Service Bulletin No.: DA20-79-07 Rev 0

Title: Oil Quantity Placard DA20-A1/DA20-100

Figure 1
Old Placard

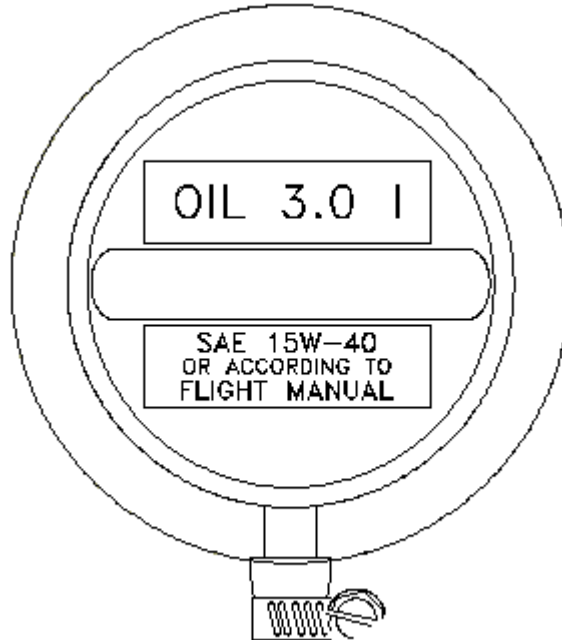
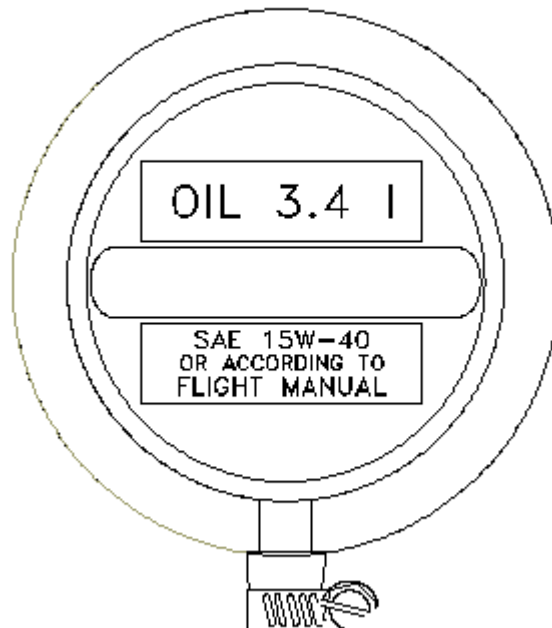
1. **ATA Code:** 7900
2. **Effectivity:** **Diamond Aircraft Model DA20 A1 aircraft.**
3. **General:** Rotax has specified the use of a new oil dipstick that increases the oil capacity of the 912 A/F/S series engines (SB-912-040 R1). As a result, the oil capacity placard located on the oil reservoir cap must be replaced.
4. **Compliance:** At the next oil change or within the next 100 hours of operation, but at the latest by November 30,2003.
5. **Approval:** The engineering data referenced or contained in this service bulletin is approved as part of the type design.
6. **Labour:** Approximately 5 minutes will be required to accomplish this service bulletin.
This estimate is for direct labor performed by a technician and it does not include setup, planning, familiarization, cure time, part fabrication or tool acquisition.

- 10.1 Remove the existing placard from the oil reservoir cap.
- 10.2 Clean the surface of the oil cap, removing all traces of adhesive, oil or dirt.
- 10.3 Remove the foil backing from the new placard and apply the placard to the oil reservoir cap in the same location and orientation as the existing one.
